O.C. 1419-2021, 10 November 2021

Building Act
(chapter B-1.1)

Construction Code — Amendment

Regulation to amend the Construction Code

Figure A-3.8.2.3.(2)(j)
Stairway in a dwelling unit
Clear width”.

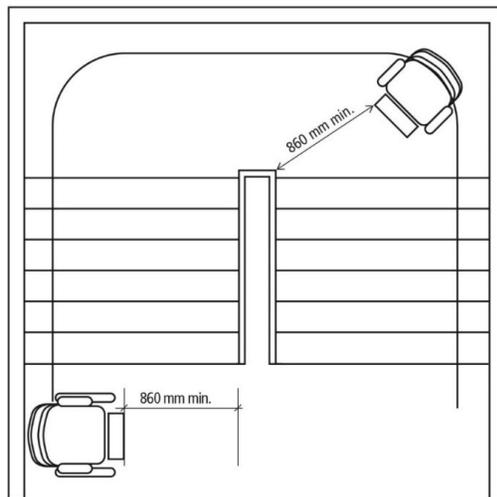
The width necessary for the installation and use of the device varies on the basis of the device chosen:

- for a stair chair lift, not less than 650 mm in addition to the 860 mm, that is, a stair width not less than 1510 mm, is to be provided;
- for a stair platform lift, not less than 1000 mm in addition to the 860 mm, that is, a stair width not less than 1860 mm, is to be provided.

Figure A-3.8.4.3.-A
Clear floor surfaces
Door rotating on a vertical axis

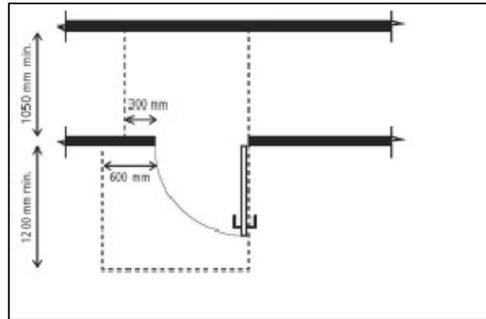
side of the door is different depending on which side the door opens. Where the door swings toward the approach side, a dimension perpendicular to the closed door not less than 1200 mm is required. The requirements in Article 3.8.3.6. apply to the door at the entrance to the dwelling unit. However, the requirements in Sentence 3.8.4.3.(2) do not apply.

Figure A-3.8.4.5(4).

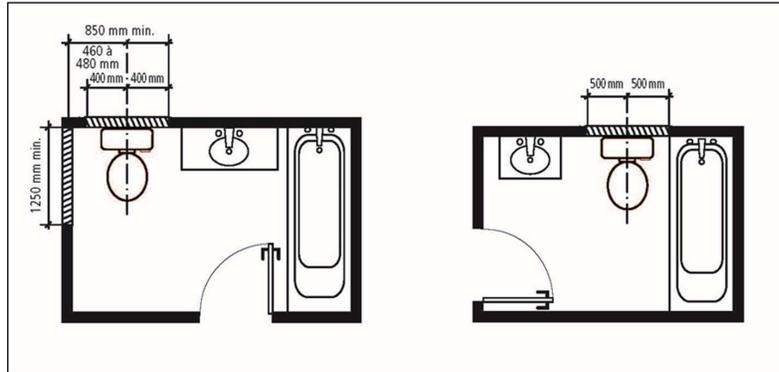
A-3.8.4.5.(4) Washroom. The installation of a wood nailing element of 1000 mm in width centred on the water closet is permitted where there is no wall adjacent to the water closet at a distance not more than 480 mm from the centre of the wall, allowing the installation of a lateral wood

nailing element over a length not less than 1250 mm. A wood nailing element not less than 1000 mm wide allows the installation of retractable grab bars on both sides of the water closet.

Figure A-3.8.5.5.(1)

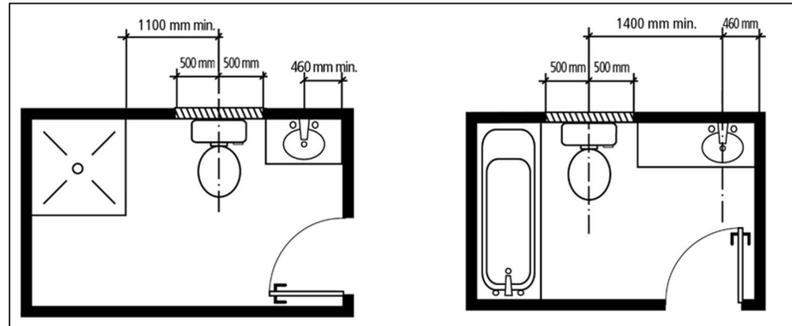
A-3.8.5.5.(1) Bathroom. The lateral transfer of a person in a wheelchair to the seat of the water closet requires a clear width not less than 900 mm adjacent to the water closet and a length not less than 1500 mm from the rear wall of the water closet. The requirement related to that surface for an adaptable bathroom allows the encroachment of a vanity or furniture for dismantling work, to meet the potential need of a person with one or more disabilities occupying the dwelling unit. However, encroachment of that space by bathroom equipment such as the shower or the bathtub is not permissible

Figure A-3.8.5.5.(2)

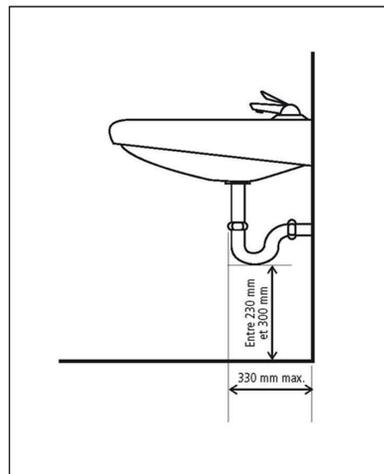
A-3.8.5.5.(2) Bathroom. To allow persons in wheelchairs front access to the lavatory, the clear height under the trap must be not less than 230 mm. In addition, to allow those persons to use the lavatory, the lavatory will have to be lowered to a height not more than 865 mm. For that purpose, the distance measured from the floor to the bottom of the trap must be not more than 300 mm

In an adaptable dwelling unit, the edge of the lavatory need not be installed at a height not more than 865 mm in relation to the floor or to allow front access to the lavatory of the bathroom. However, an appropriate installation of the plumbing is required to allow future adaptation.

Figure A-3.8.5.7.(2) and (3)
Indications for kitchen sink plumbing”.

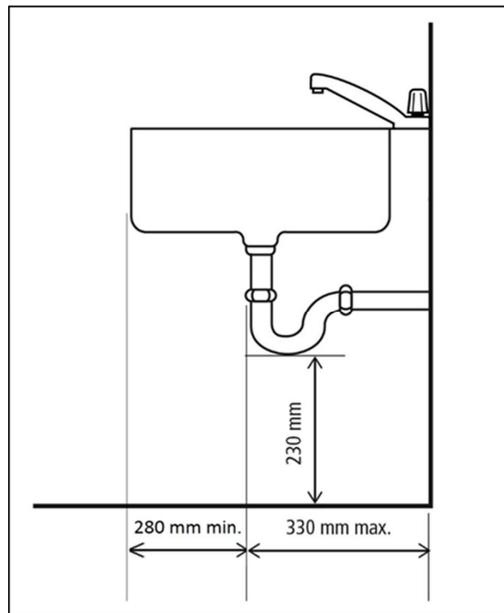
In the case of a sink installed in a kitchen island, the longitudinal dimension to give persons in wheelchairs front access to the kitchen sink may be measured from the front edge of the counter of the island containing the sink and must be not less than 280 mm.

In an adaptable dwelling unit, counters need not be installed at not more than 865 mm and kitchen furniture is allowed under the sink. However, an appropriate installation of the plumbing is required to allow future adaptation.
